**SAN ANTONIO WATER SYSTEM  
CENTRAL WATER INTEGRATION PIPELINE  
TERMINUS TANK PROJECT  
SAWS Job No. 18-8609  
SAWS Solicitation No. CO-00170**

**ADDENDUM No. 3  
March 23, 2018**

3/22/2018 10:19:18 AM - O:\PROJECTS\ORLANDO\IER09308\20-09308-18001-BICAD\SHSHEETFILES\TERMINUS\_TANK\KID-1303\_GST DETAILS I.DWG - MARTINEZ, LORENZO

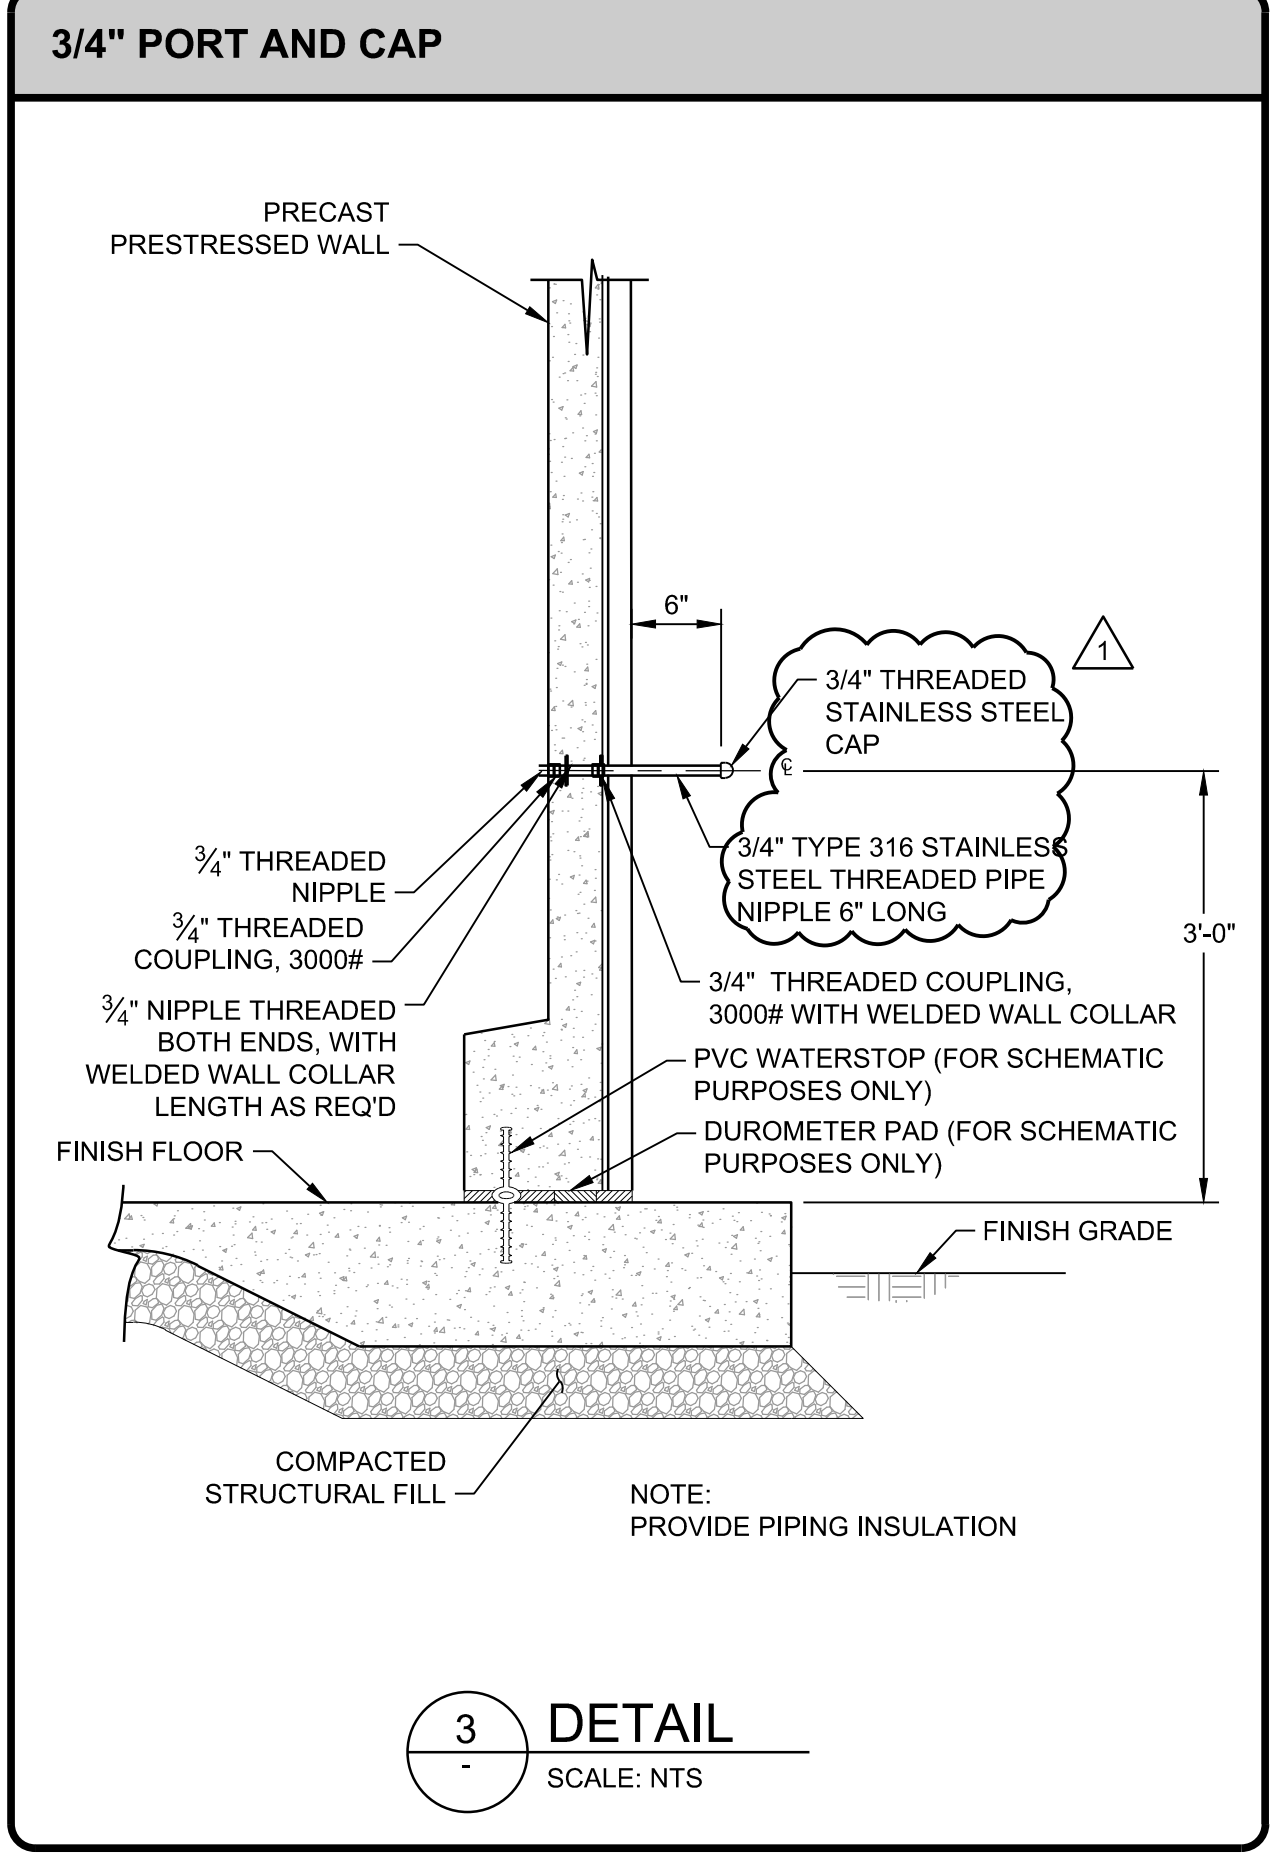
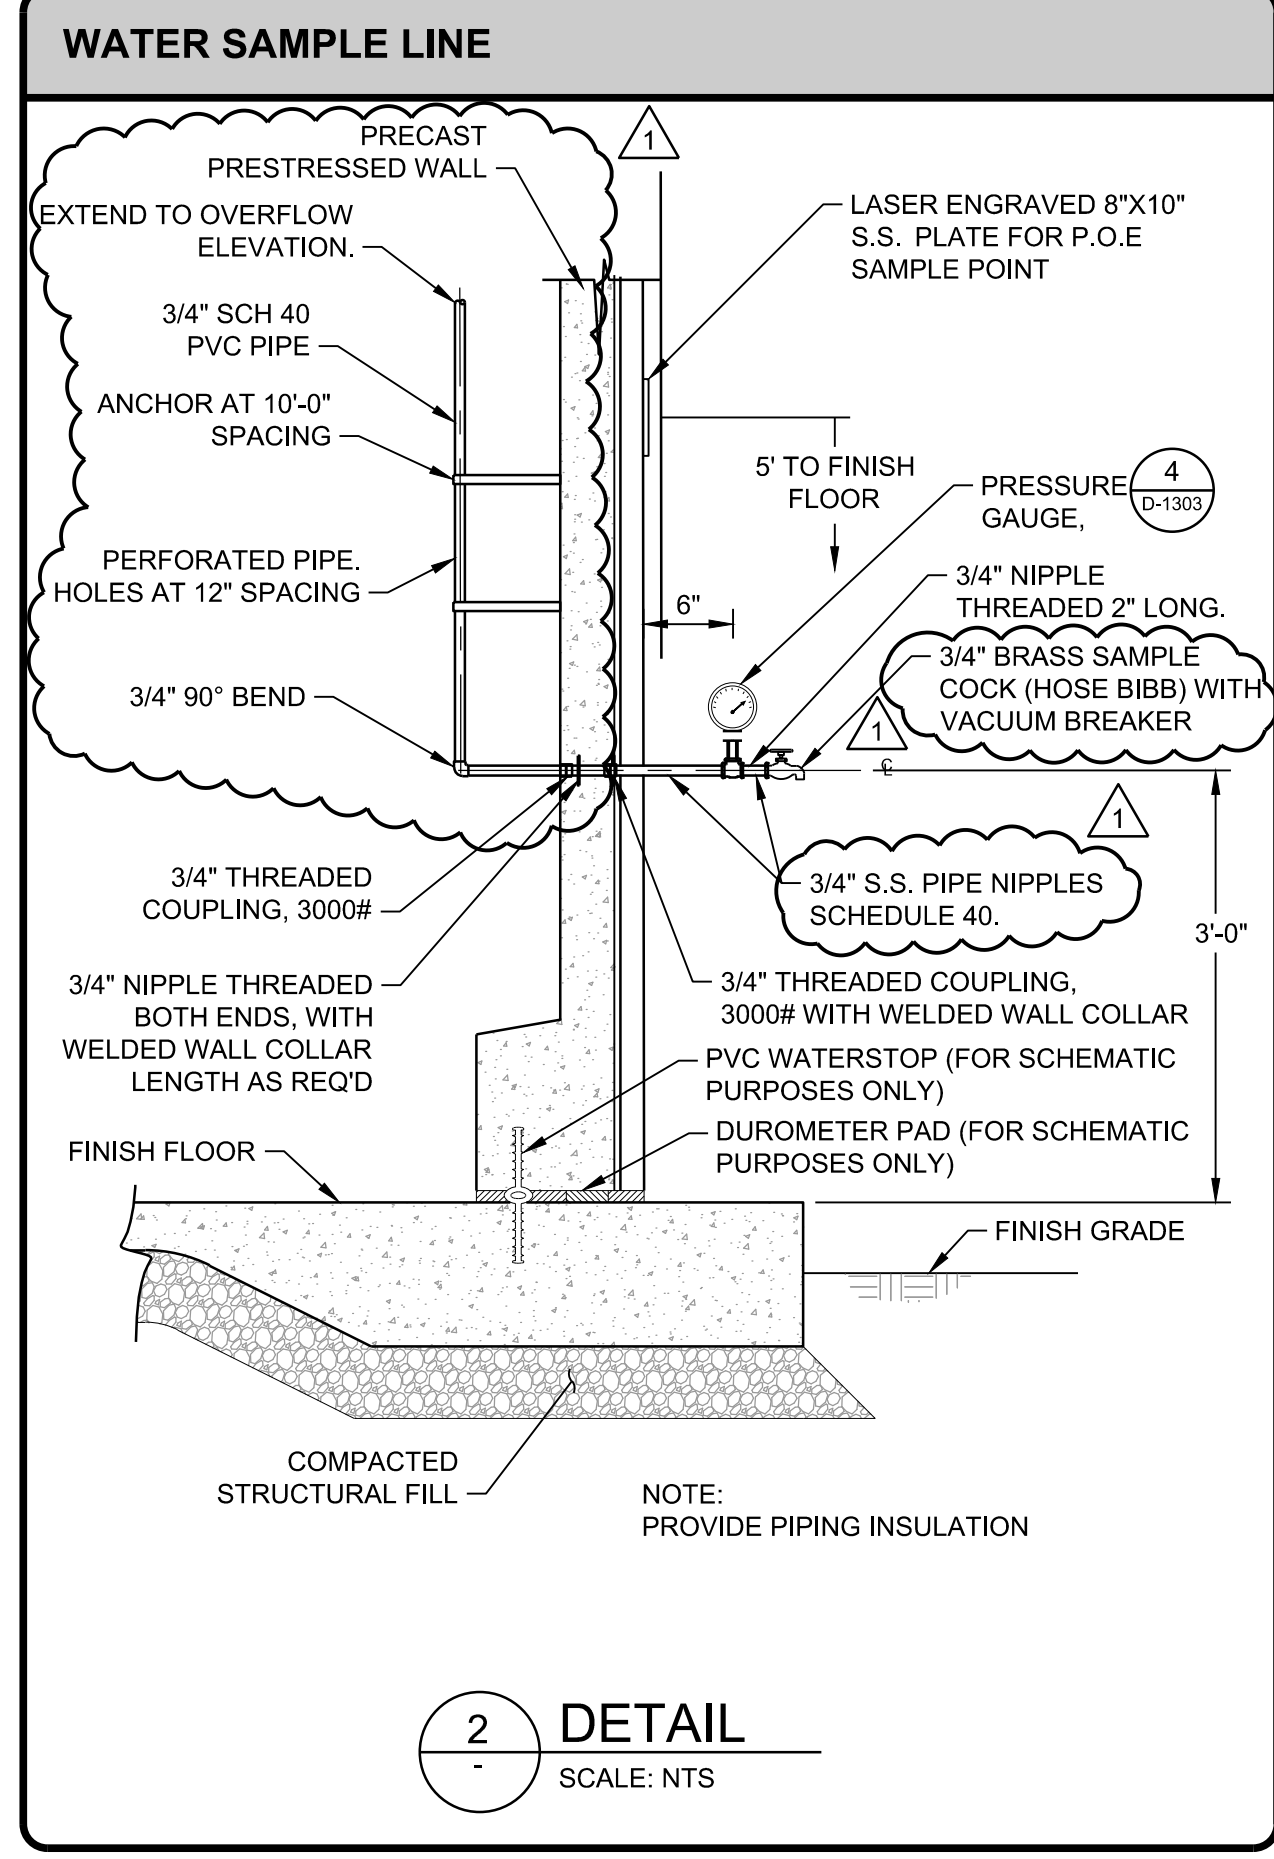
- Q7. Plans Sheet D-1302, Detail 4, indicates the use of a weir cone for the inlet riser. Typically inlet risers terminate in a plain end, please confirm if this is acceptable for this project.

- A7. A weir cone will not be installed on the inlet riser. As part of this addendum, Detail 4 (on Sheet D-1302) has been updated to show a short radius 90-degree bend (in lieu of a weir cone) at the terminus point. The invert of this 90-degree bend shall correspond to that of a plain end pipe (if it were used instead).
